STAFF REPORT

Re: <u>Mercer Mountain Estates – Final Subdivision Plat Request</u>

Application No.: 2025-0016-SUB

EXHIBIT G SITE PLAN

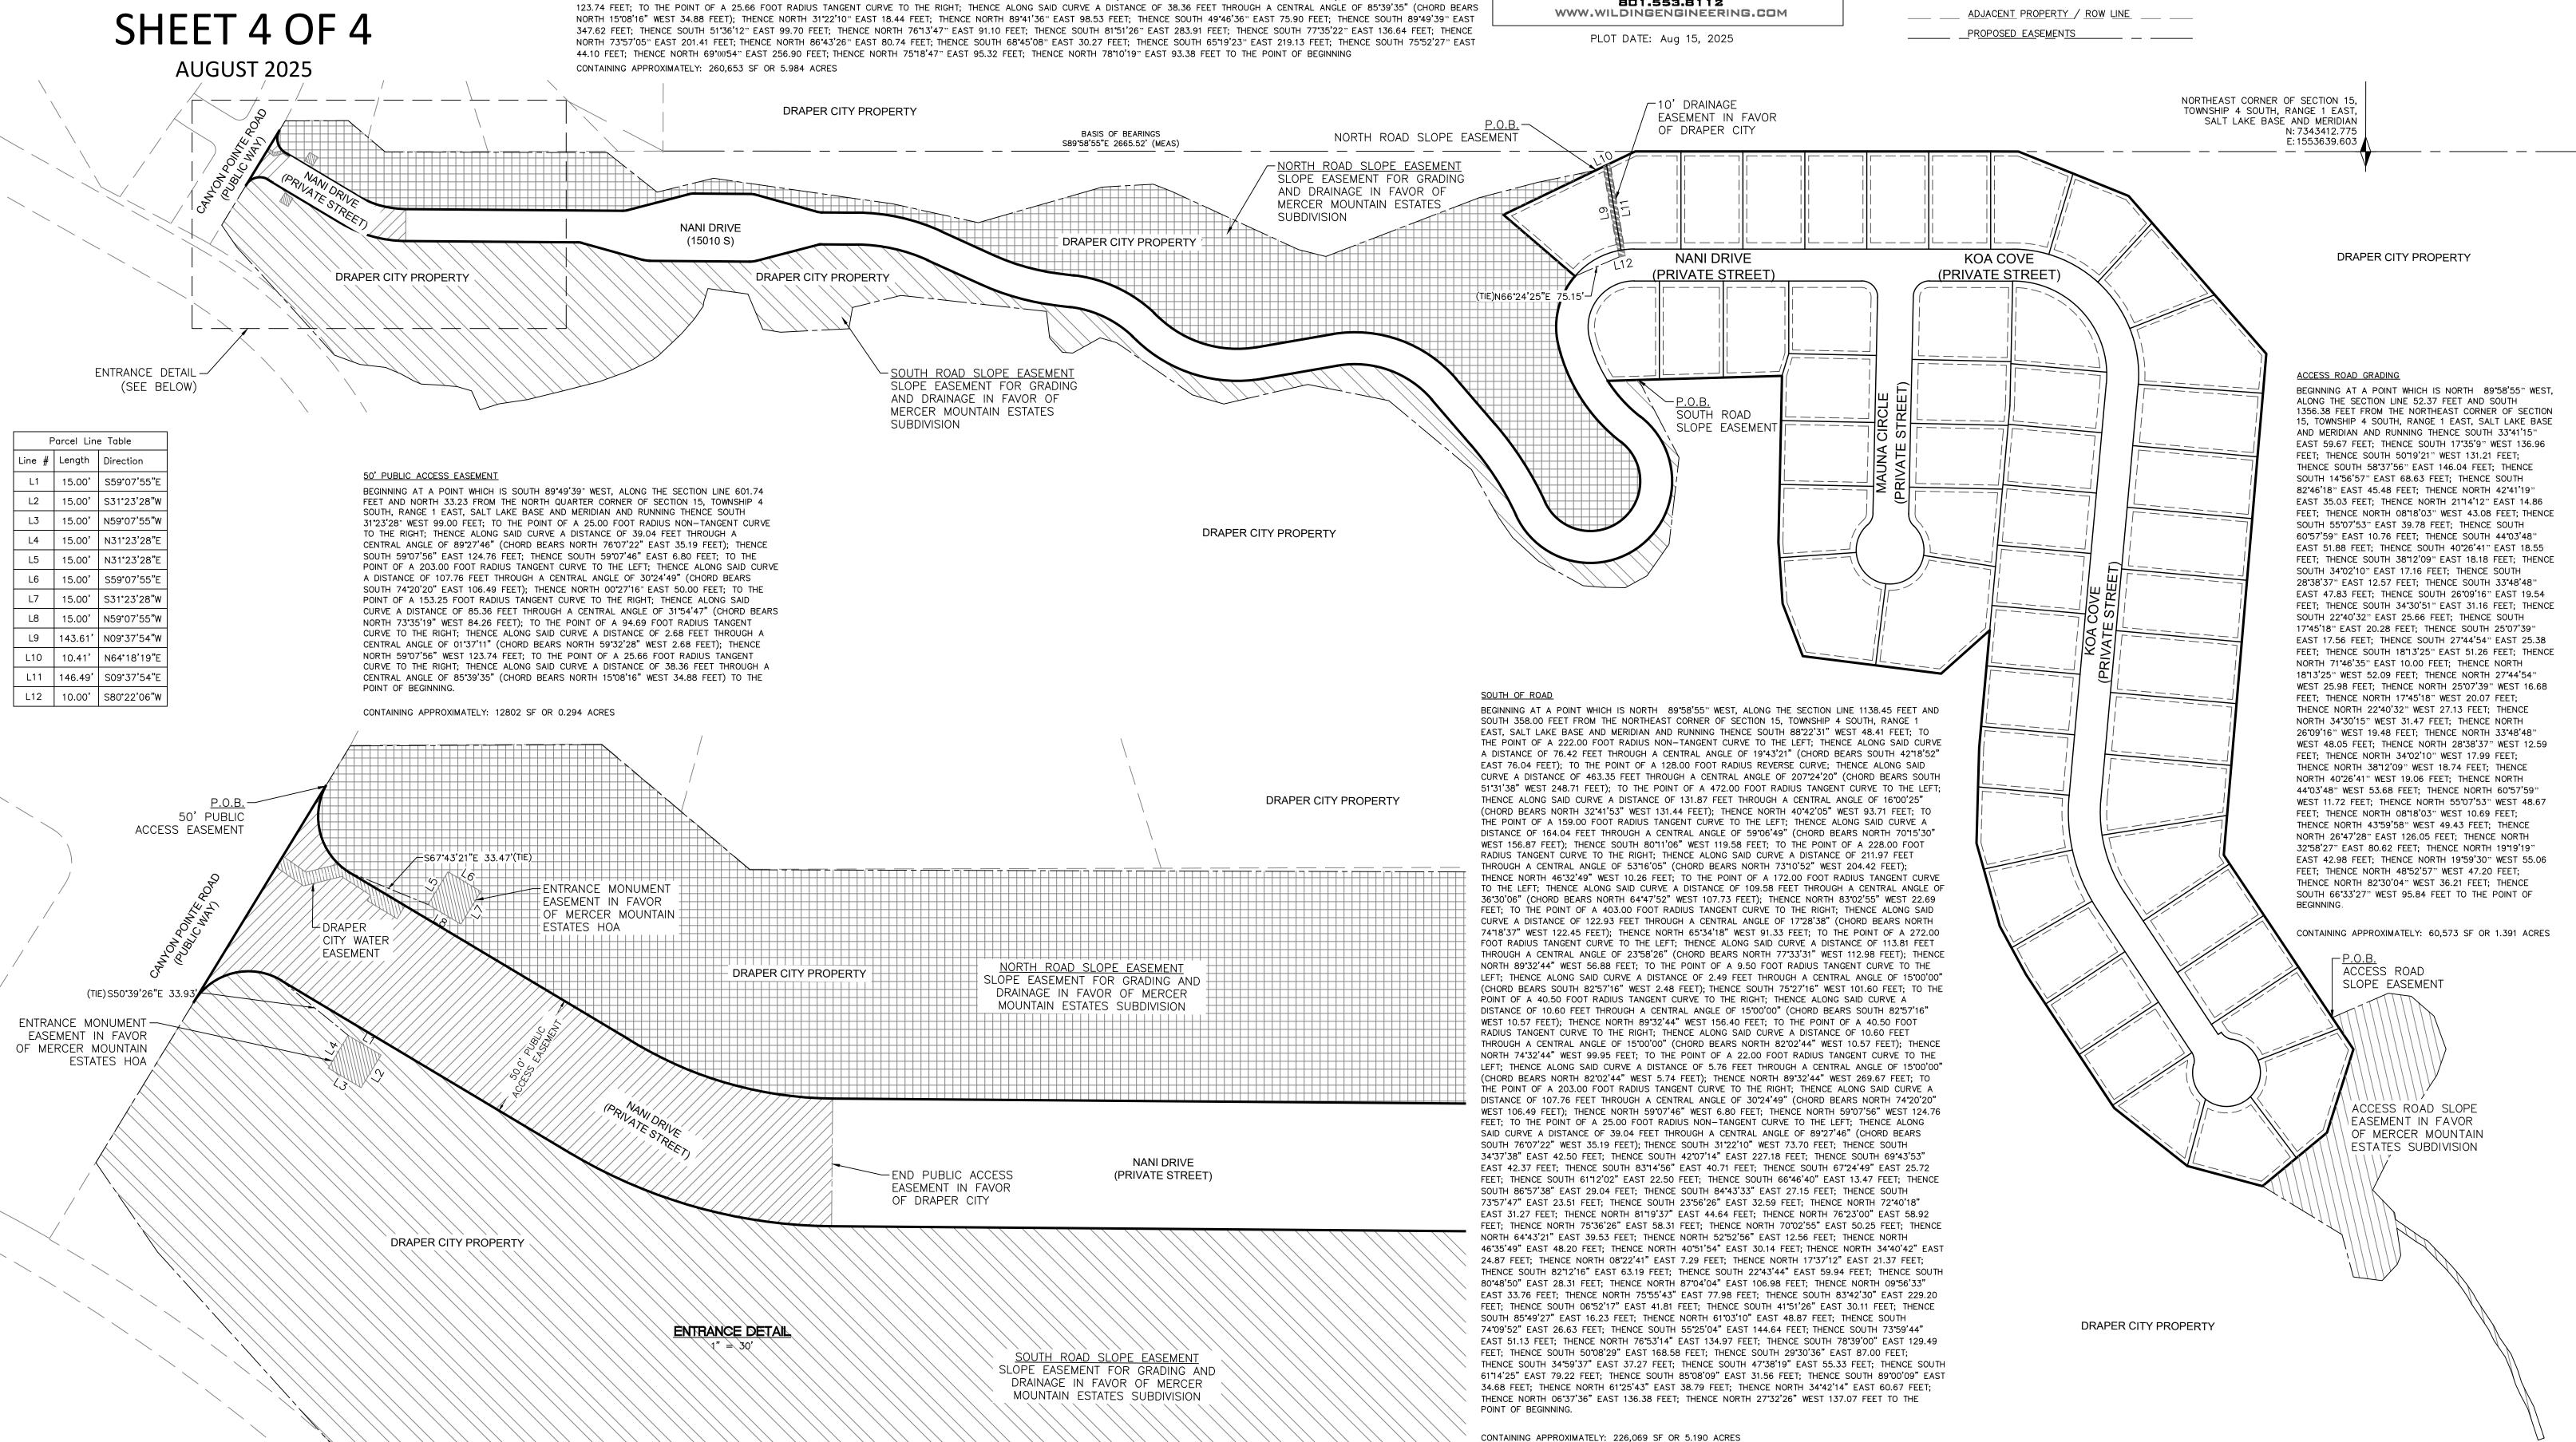
- 3. Owner's dedication is found at DCMC 17-4-030(N)(2). *Update dedication language to the dedication within city code.*
- 4. Add any drainage easement for swales crossing lots, as required by the drainage and grading plan per DCMC 17-5-040 and 18-3-150. Minimum easement width shall be 10 feet. Add **private** drainage swale between lots 1 and 2. Comment partially addressed update easement to **private** drainage easement.

- 5. The city waterline and meter vault easement be a minimum of width of 20 feet, centered on the pipeline from Canyon Pointe Rd and surrounding the master meter vault.
